# **UT to Town Creek Restoration Project – Option A Final Year 6 Monitoring Report**

**DMS Project ID Number – 94648; NC DEQ Contract No. 003277**

**Subject:** Response to DMS Comments for MY6 Draft Report  
UT to Town Creek Mitigation Site, Stanly County  
DMS Project #94648, DEQ Contract #3277

DMS MY6 Draft Report Comments:

Location of Added Creation Area from Wetland Boundary Adjustment as Compared to Original Analysis

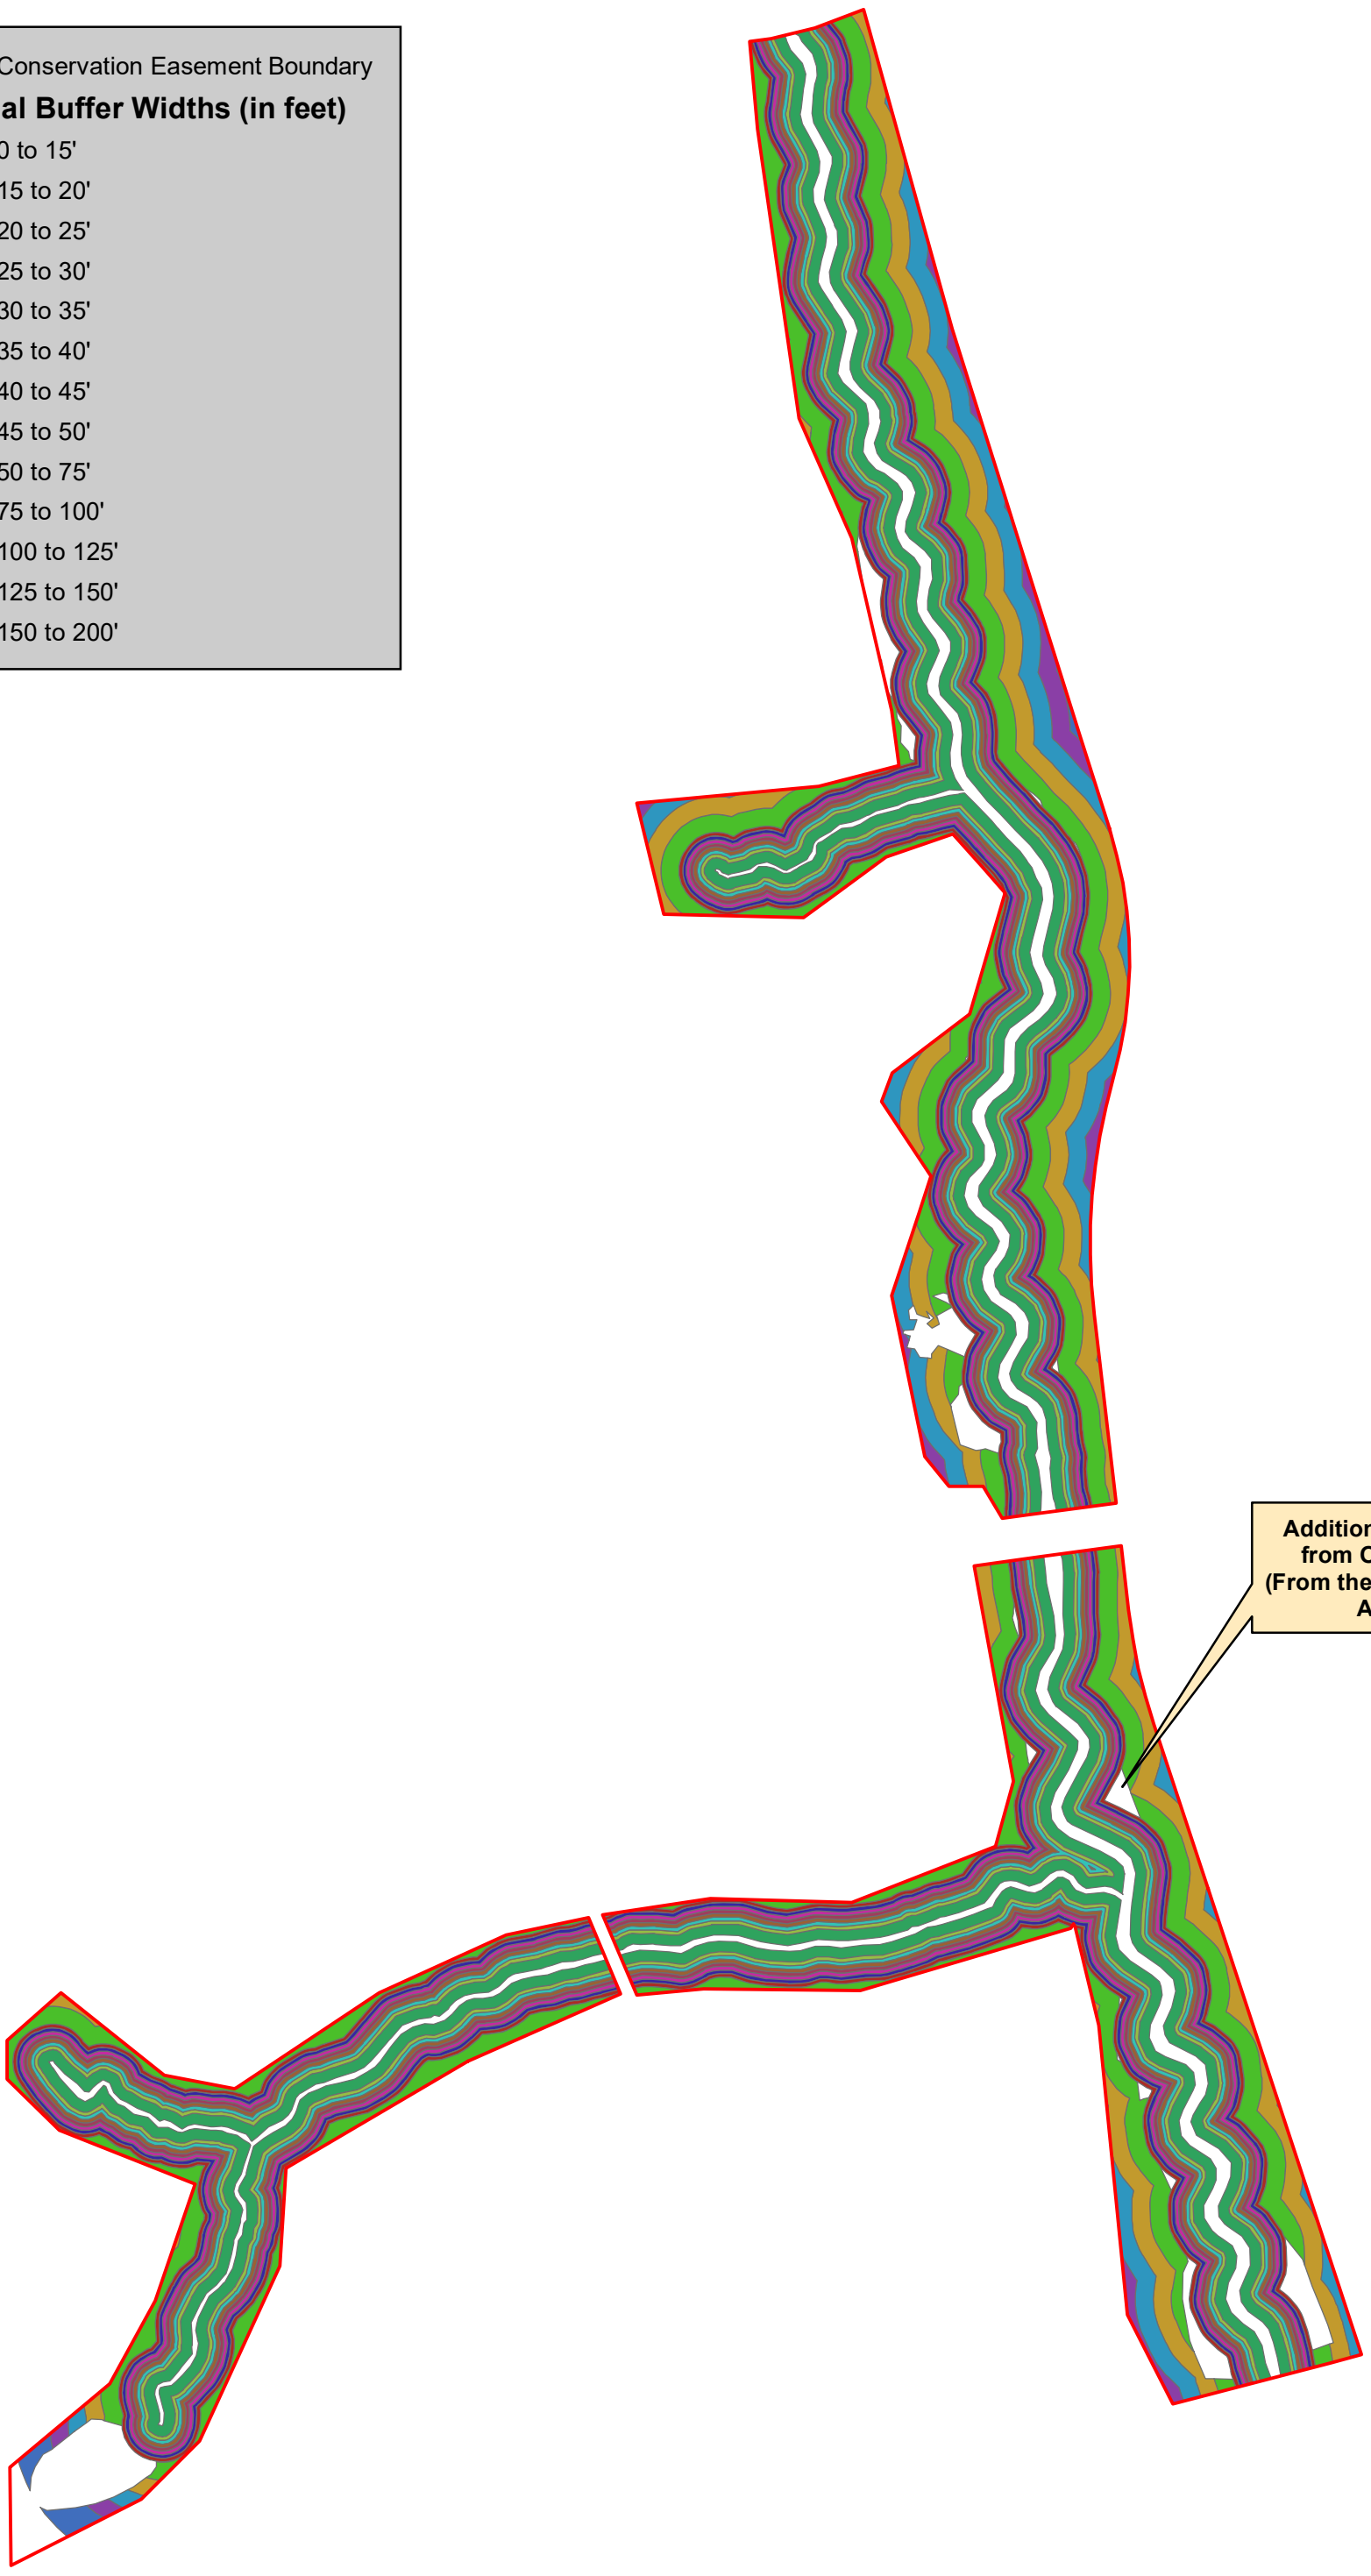
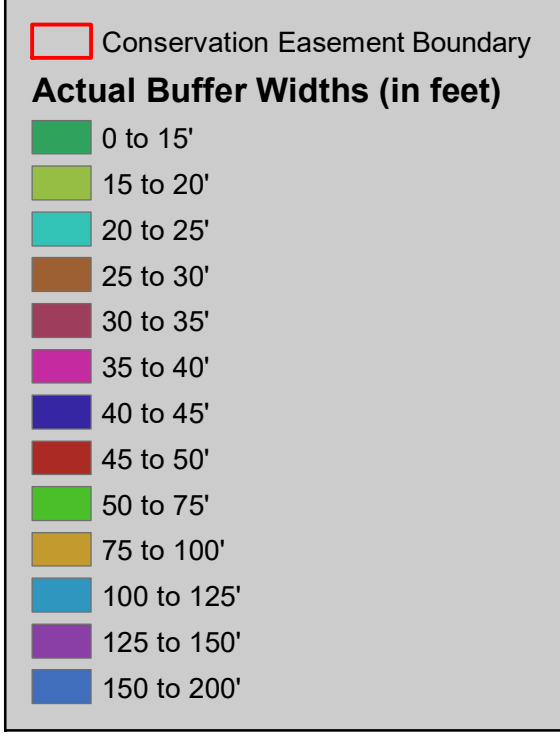
This minor adjustment of the credited wetland boundaries also affected the results of the buffer spreadsheet tool used in the mitigation plan to determine additional stream credits from the implementation of wider riparian buffers. As per IRT request, the same 2018 version of the buffer tool originally used for the mitigation plan was used again to re-evaluate the stream credit calculation, only using the new wetland boundaries. As shown below in Table 2, the analysis revealed that the addition of the Creation area results in the loss of 2.68 stream credits as compared to the original analysis (from 265.32 to 262.64 credits).

-As we are now technically down 2.680 SMU from our official credit table from the loss of buffer tool credits, DMS is concerned that there will need for mit plan or contract adjustments and Baker is concerned about loss of credits for payment. DMS suggested that if the number is really that small that the IRT might just let it slide and closeout with full credits intact, meaning no further mit plan or contract adjustments needed. Is that possible? If so, we will keep the wetland area as we now have it and move forward. However, if that's not acceptable I would offer an easy solution to make things simpler all around. I can adjust the proposed wetland boundary to kick out a small triangle of about 1,400 ft<sup>2</sup> in size that is affecting the buffer tool credit results (see the attached figure). We would still be able to compensate for the wetland loss but not lose any SMU. I had thought about that a while back but felt uncomfortable obviously skewing a boundary for that purpose. It felt like I was gerrymandering the boundary for a self-centered intent! However, with the IRT's permission, I could do that and it would solve that issue. But if being off by 2.680 SMU isn't a big deal to you then we can just go with what we have.

Thanks for all the information. The wetland adjustment plan is acceptable to the IRT. Given that 2.680 credits is a small amount, and removing sections of wetlands and applying the new buffer tool complicates the issue, no further mitigation plan or contract adjustments will be needed. We'll plan on closing the site out as originally proposed.
